**RE: Luna Vita Subdivision  
Grading and Drainage Plan  
Engineer's Stamp Date: 12/28/18  
Hydrology File: C19D066**

Based upon the information provided in your submittal received 01/04/2019, the Drainage Report and Grading Plan **is not** approved for action by the DRB for Preliminary Plat or approved for Grading Permit. The following comments need to be addressed for approval of the above referenced project:

**LUNA VITA SUBDIVISION**  
**A REPLAT OF LOTS 31-32, BLOCK 3, UNIT 2, TRACT 2, NAA**  
**GRADING & DRAINAGE PLAN**

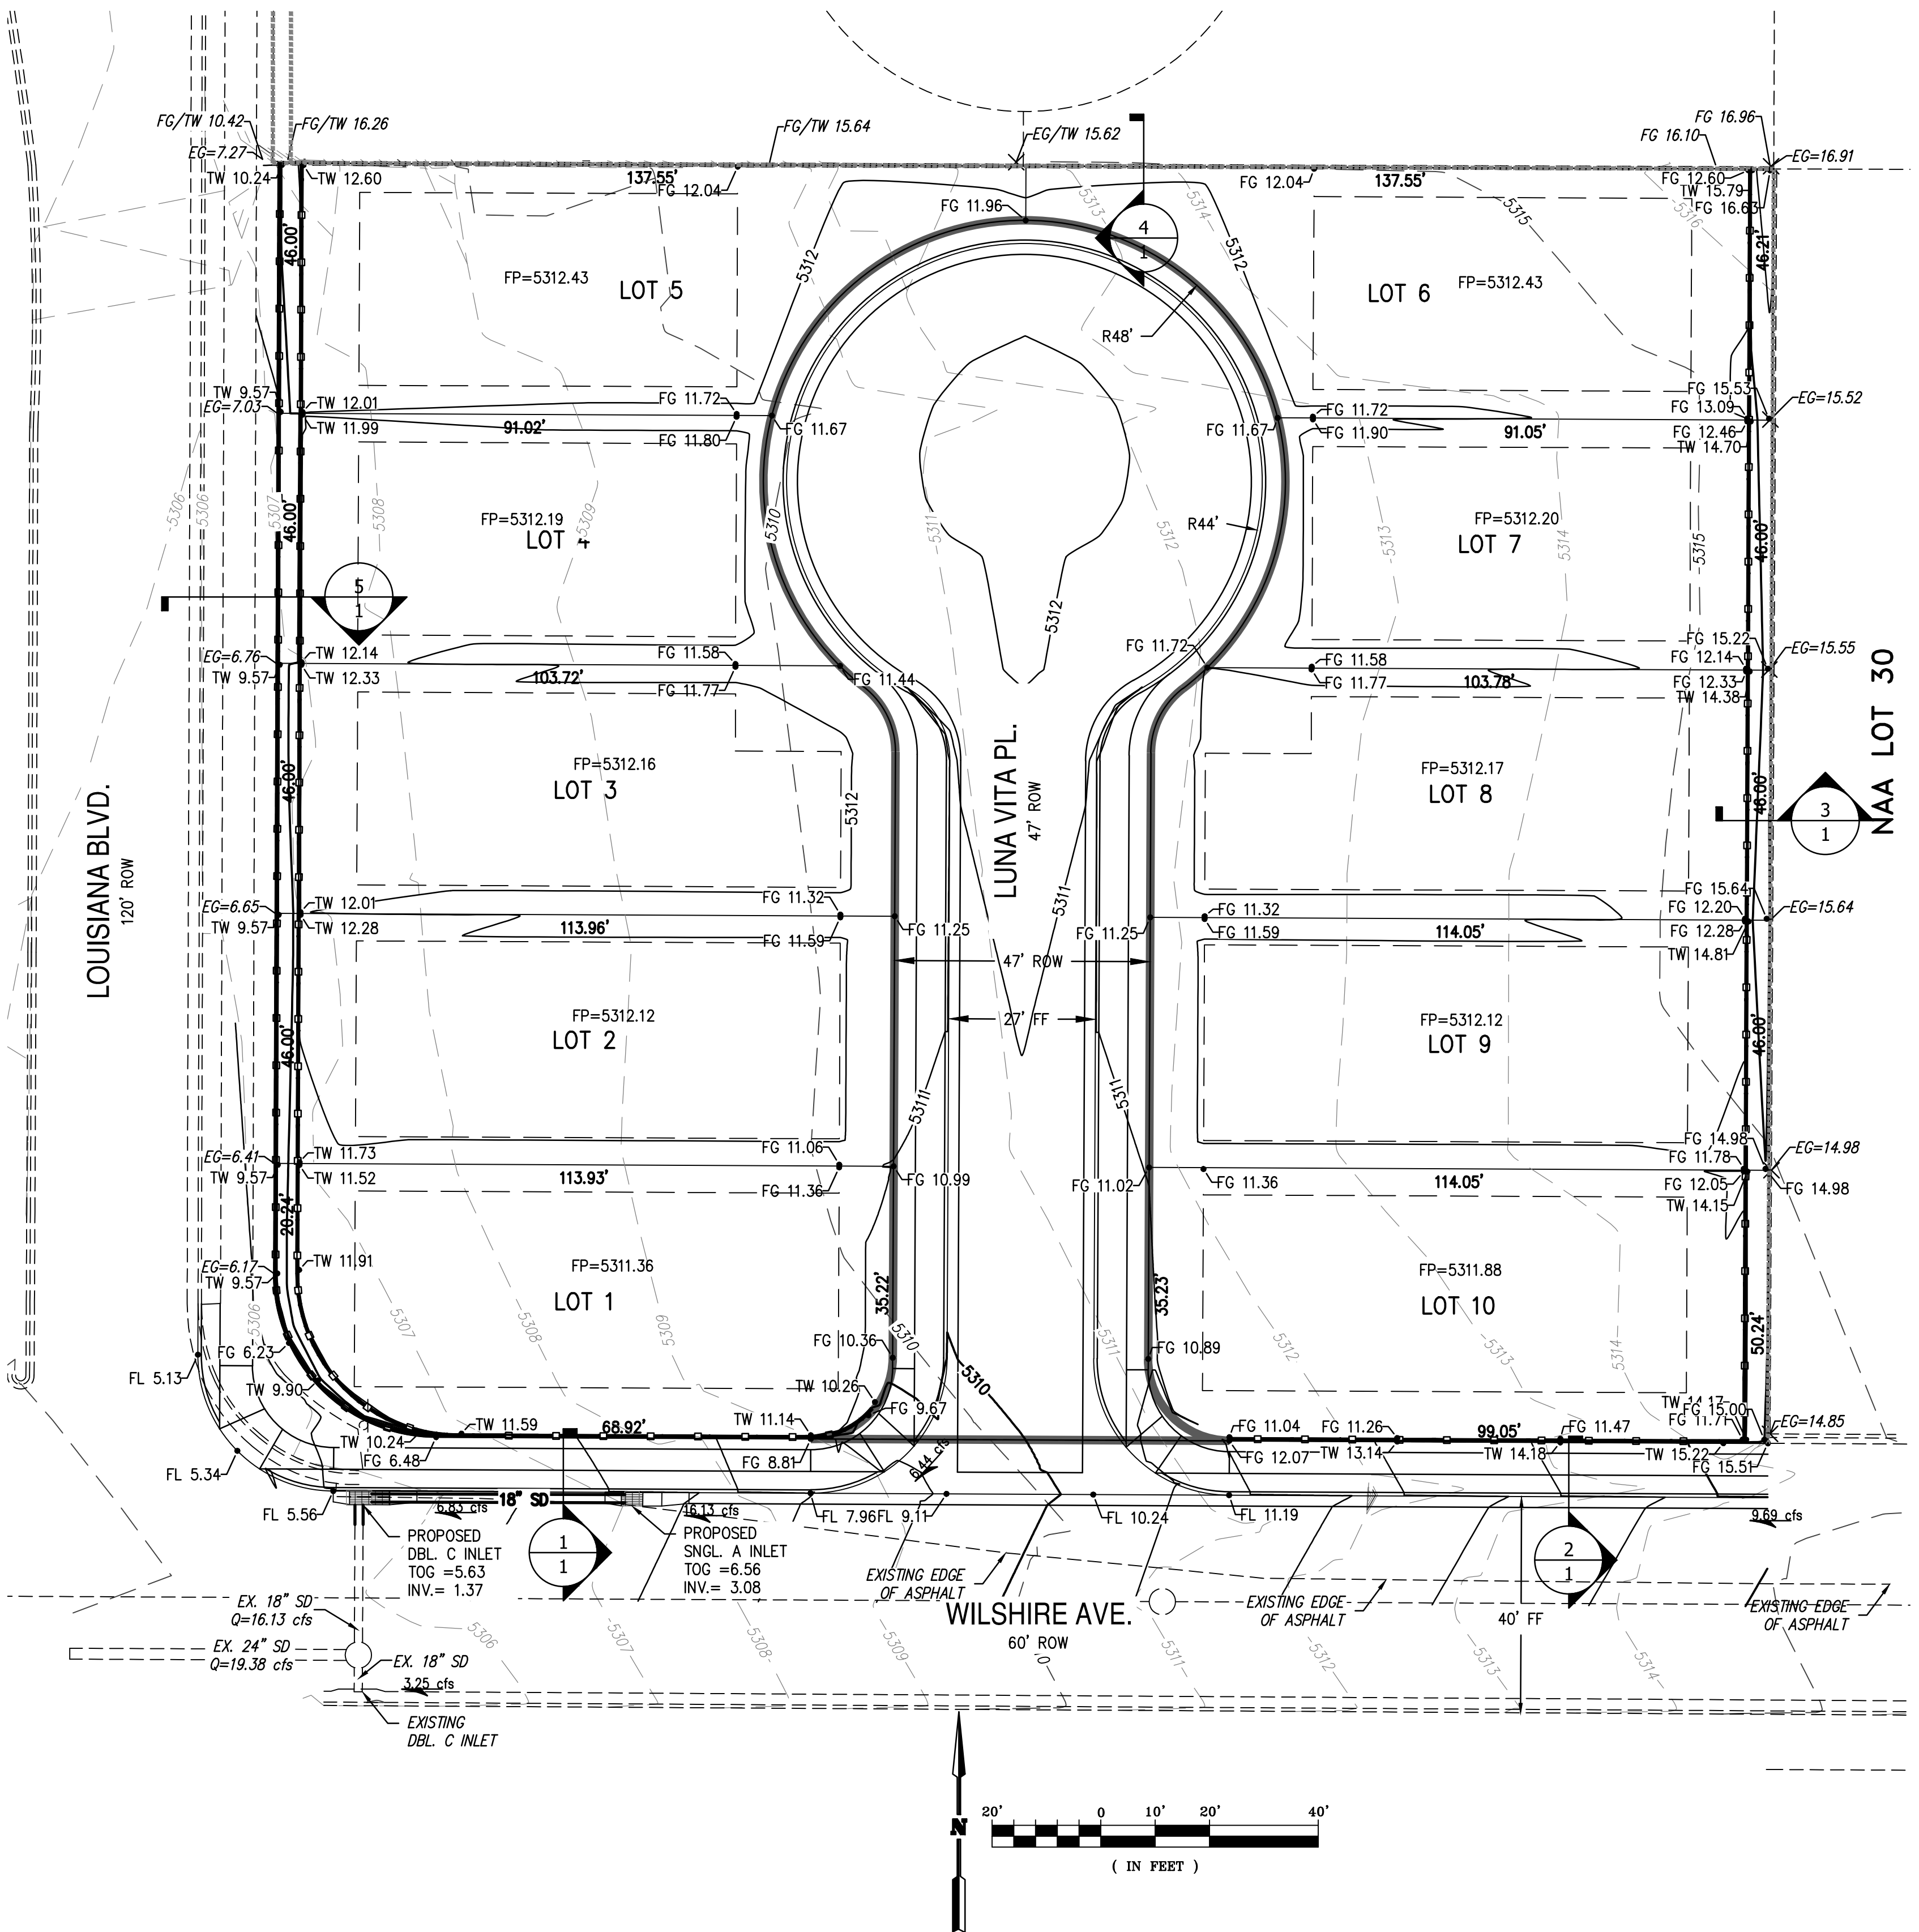
1. Just to the north of the site, please add the adjacent lot information.
2. All along the western lot corners, please add either the finished grade or make to top of wall elevations higher per Section 5.

3. All along the property line within the cul-de-sac, there is a think line. What is this? If it is not needed, then please delete the line.
4. At the southeast corner of the Lot 10, please revise the location of the finished grade so that the two other grades can be read.

1 SECTION AT PROPERTY LINE Scale: 1:5  
2 SECTION AT PROPERTY LINE Scale: 1:5  
3 SECTION AT PROPERTY LINE Scale: 1:5  
4 SECTION AT PROPERTY LINE Scale: 1:5  
5 SECTION AT PROPERTY LINE Scale: 1:5

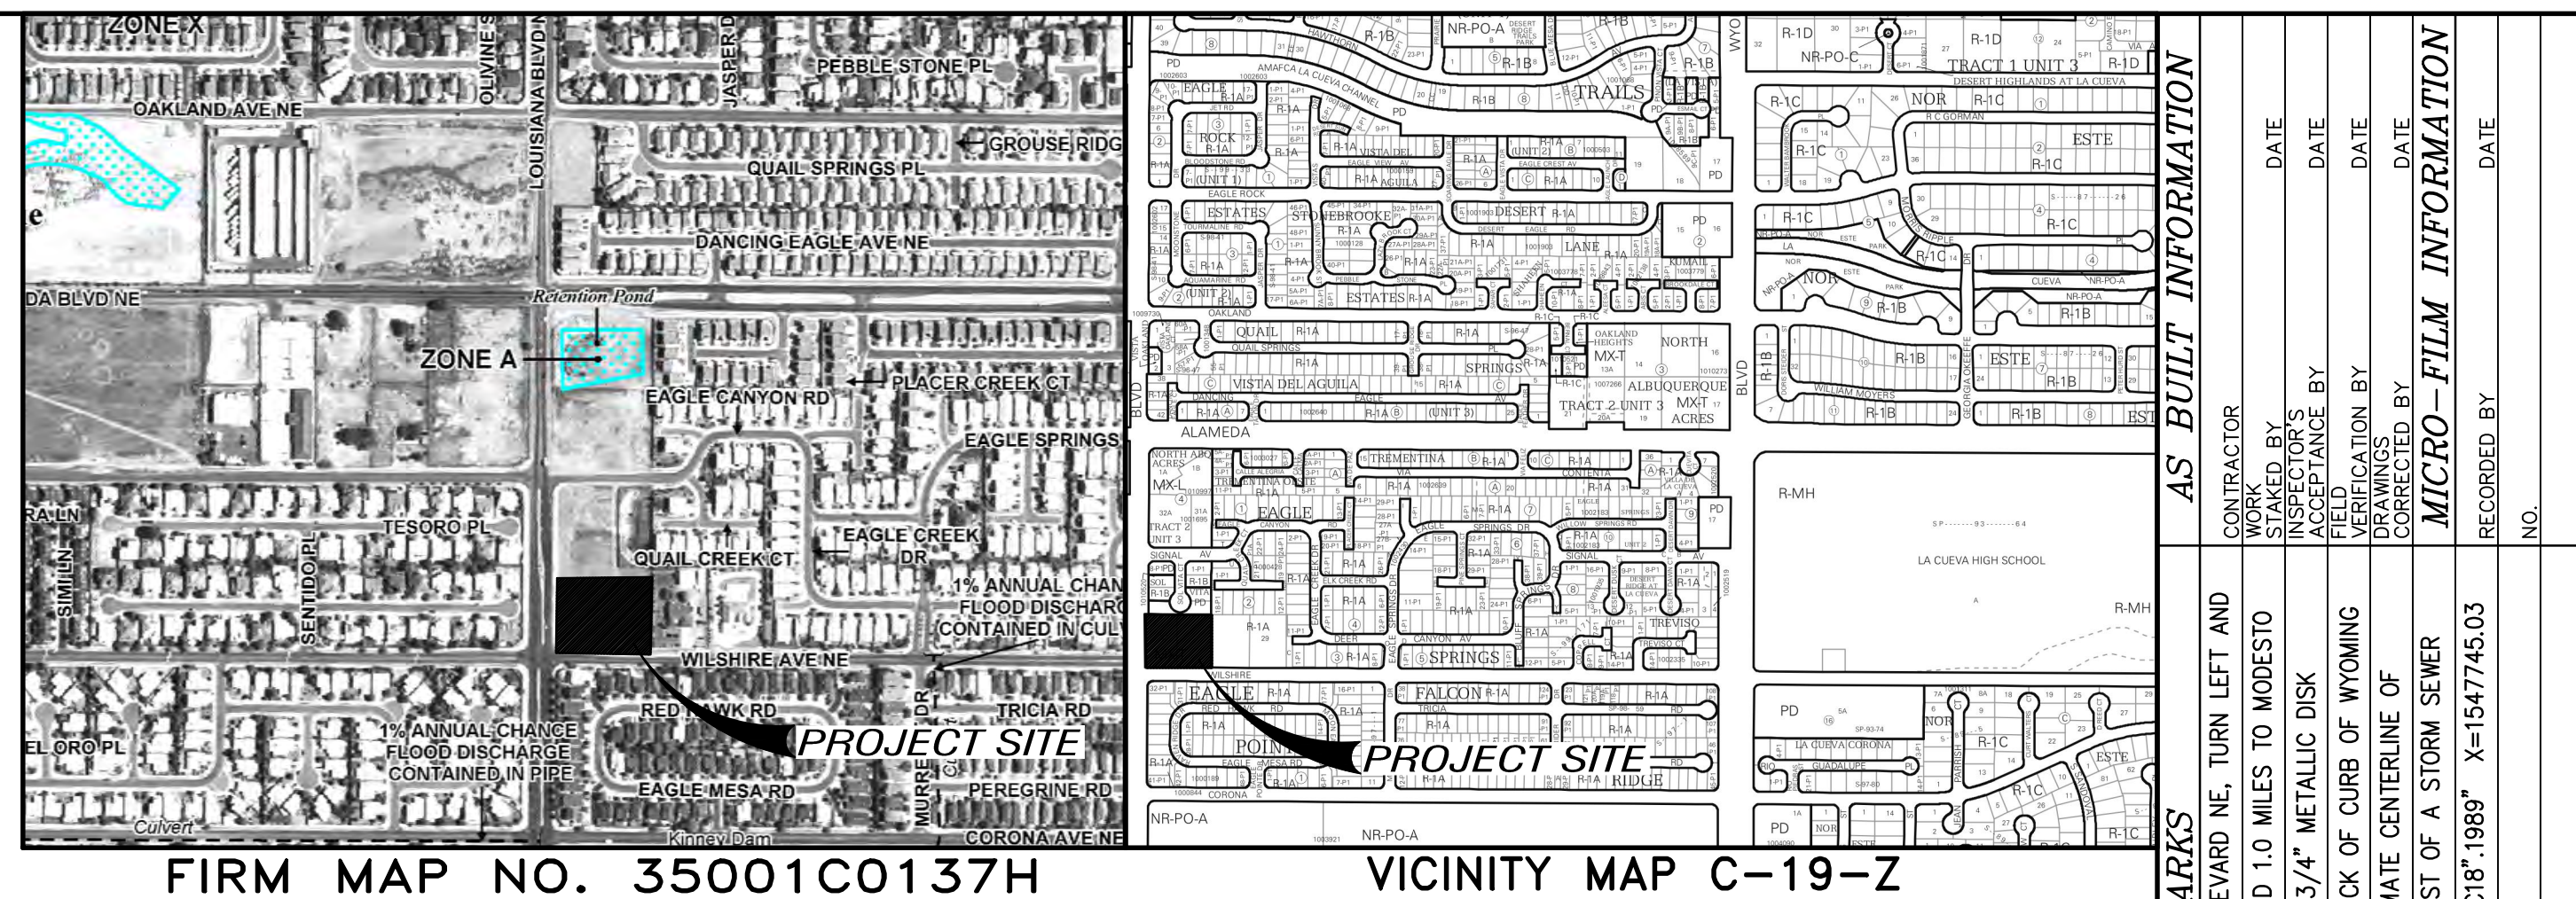
14. Please label Wilshire R.O.W. in Section 1 and Louisiana R.O.W. in Section 5.
15. Please provide all footers in the retaining walls in all sections. Per DPM Ch. 22.5.B, grading and construction of retaining walls at or near the property line must demonstrate that the adjacent property is not damaged or its use constrained. Any such encroachment by the wall or grading must be accompanied by written permission of both landowners.
